Access Compliance Report

Public Rights-of-Way

(Curb Ramps)

Intersection ID: 52988	Main Street: LANDING_PLACE_LN	Cross Street: GREYTHORNE_DR	Location: NW
ADA ID: 304C6D8E49FC	Ramp Type: BlendTrans1	Initial Pass/Fail: Fail	Overall Compliance: No
		Severity Score: 12.5

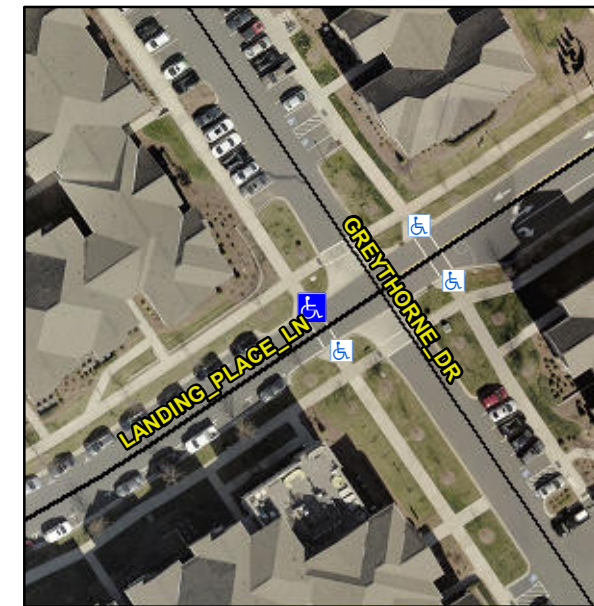
Not Found, R304.5.3

Compliance	Description	Data	Compliance	Description	Data
N/A	Ramp Length (in)	87.0	Yes	BlendTrans Slope (%)	4.5
Yes	Ramp Width (in)	83.0	No	BlendTrans XSlope (%)	5.2
N/A	Flare Type LT	N/A	N/A	Flare Type RT	N/A
N/A	Flare Slope LT (%)	N/A	N/A	Flare Slope RT (%)	N/A
N/A	Flare Traversable LT?	N/A	N/A	Flare Traversable RT?	N/A
N/A	Landing Length (in)	N/A	N/A	DWS Provided?	N/A
N/A	Landing Width (in)	N/A	N/A	DWS Contrast?	N/A
N/A	Landing Slope (%)	N/A	N/A	DWS Length (in)	N/A
N/A	Landing X Slope (%)	N/A	N/A	DWS Full Width?	N/A
N/A	Landing Curb? (Y/N)	N/A	N/A	DWS Offset (in)	N/A
N/A	Shared Landing?	N/A			
N/A	Gutter Ponding?	N/A	N/A	Gutter Slope (%)	N/A
N/A	Gutter Lip Ht (in)	N/A	N/A	Gutter X Slope (%)	N/A
N/A	Painted X Walk1?	Yes	N/A	Painted X Walk2?	N/A
	X Walk 1 Direction	To SE		X Walk 2 Direction	N/A
	X Walk 1 Width (in)	82.0		X Walk 2 Width (in)	N/A
	X Walk 1 Slope (%)	2.5		X Walk 2 Slope (%)	N/A
	X Walk 1 X Slope (%)	3.1		X Walk 2 X Slope (%)	N/A

N/A	Ramp inside XWalk1?	Yes	N/A	Ramp inside XWalk2?	N/A
	Road Slope (%)	3.1		Clear Space?	N/A
	Road X Slope (%)	2.5	N/A	Clear Space to XWalk (in)	N/A
N/A	Any Obstructions?	N/A	N/A	Storm Grate/Utility Hazard?	N/A
	Obstruction Type			Storm Grate/Utility Type	
		N/A			N/A
			Yes	Surface Condition? (G/P)	Good
			No	Curb Slope (%)	14.9

Remove & Replace Curb Ramp With Two New Directional Ramps or Equivalent.
